Access Compliance Report Public Rights-of-Way (Curb Ramps)

Main Street: HEDWIG_RD Cross Street: DONNIS_RD Location: S

ADA ID: RPRK220217163840 Ramp Type: Type 1 - Perpendicular Initial Pass/Fail: Pass Overall Compliance: No Severity Score: 5

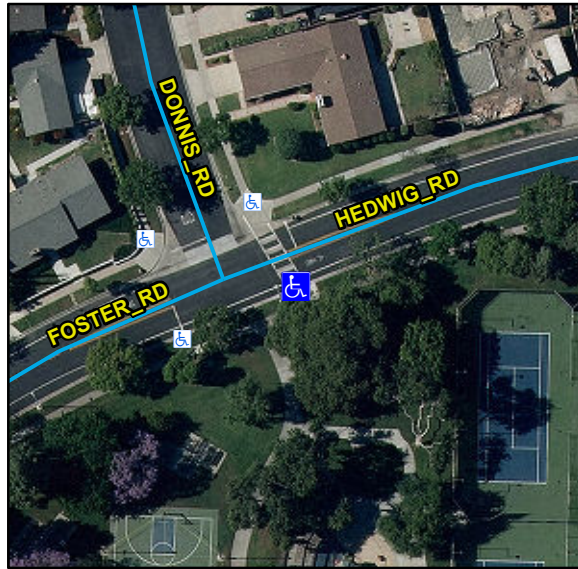
Remove & Replace Landing. Remove & Replace Gutter.

R304.2.1, R304.5.4, STD 1115
